**Flood Control Project Maintenance
Levee Inspections**

Maintenance Issue Types Only, Levee Inspection Report By Mile - Spring 2020

Reclamation District No. 0544 Upper Roberts Island

Waterway	Bank	Unit Miles	Inspection Start/End	Inspector
Unit No. 01 San Joaquin River	Left	6.05	04/29/2020 04/29/2020	Alberto De Leon

Photo 1 of 3 : LEVAL_SP_2020_562_4770.jpg

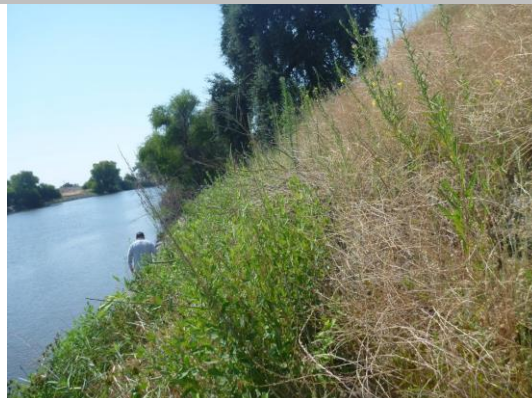
LM Start	3.79	Rating **	A/W	Issue No.	135
LM End	3.82	Issue Type +	Ma	Location *	WS
Category	Supplemental			GPS Latitude/Longitude	
				Start	End
Item	2017 Storm Damage			37.829800 °	37.829400 °
				-121.312100 °	-121.312000 °
DWR ID	LMA 468-469				
Comment Code					
Inspector Comment					
Planned For Repair.					
Levee Evaluation Comments					
Description:Slope protection repairs are needed along the waterside slope due to erosion and riprap displacement from high water. Based upon levee inspections, it was determined the waterside levee slope is eroding, deteriorating, and degrading. The eroded levee sections need to be restored back to design standards to prevent further deterioration and damage.					
Site ID No:562					
Site Designation:LMA 468-469					
Repair Type: Erosion					
Rating:Serious					
Field Date:8/11/2017					
Notes: Site combined with LMA-469:

Photo 2 of 3 : LEVAL_SP_2020_551_4818.jpg

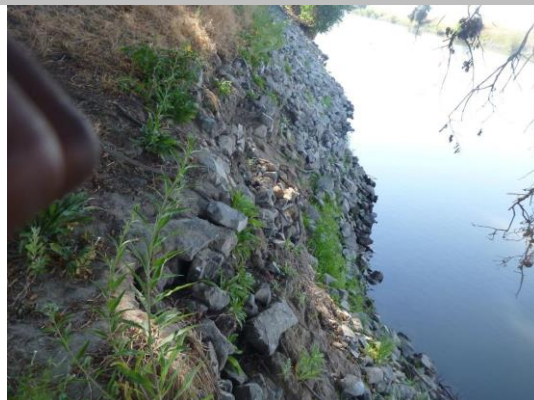
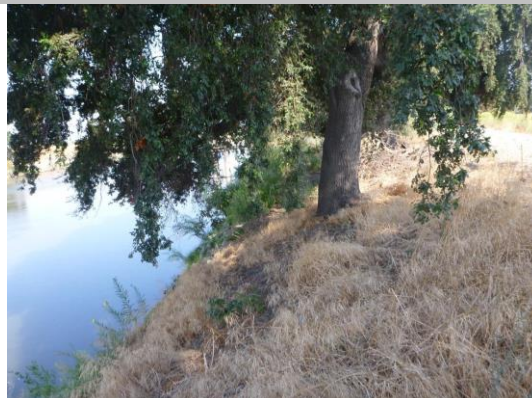
LM Start	2.17	Rating **	A/W	Issue No.	87
LM End	2.18	Issue Type +	Ma	Location *	WS
Category	Supplemental			GPS Latitude/Longitude	
				Start	End
Item	2017 Storm Damage			37.820300 °	37.820300 °
				-121.345600 °	-121.345700 °
DWR ID	LMA-457				
Comment Code					
Inspector Comment					
Planned For Repair.					
Levee Evaluation Comments					
Description:Slope protection repairs are needed along the waterside slope due to erosion and riprap displacement from high water. Based upon levee inspections, it was determined the waterside levee slope is eroding, deteriorating, and degrading. The eroded levee sections need to be restored back to design standards to prevent further deterioration and damage.					
Site ID No:551					
Site Designation:LMA-457					
Repair Type: Erosion					
Rating:Serious					
Field Date:8/18/2017					
Notes:
